Errata

Applies to IP65 step motors from pilot production build

Eight lead motor connected in PARALLEL to a bipolar drive.

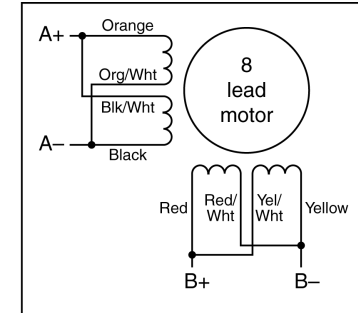
1. Some units have cables that are rated 80°C. These motors should be operated such that the case temperature does not exceed 80°C.
2. The wire colors may differ from our standard. See wiring diagrams below and on the back.

Motors with orange, orange/white, red, red/white, black, black/white, yellow, yellow/white.

Eight lead motor connected in PARALLEL to a bipolar drive.

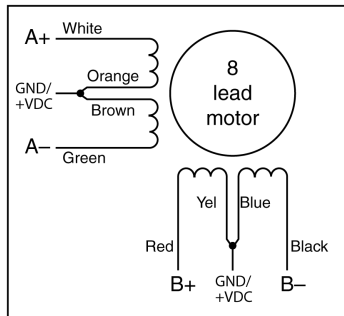
Motors with white, orange, brown, green, red, yellow, blue, black.
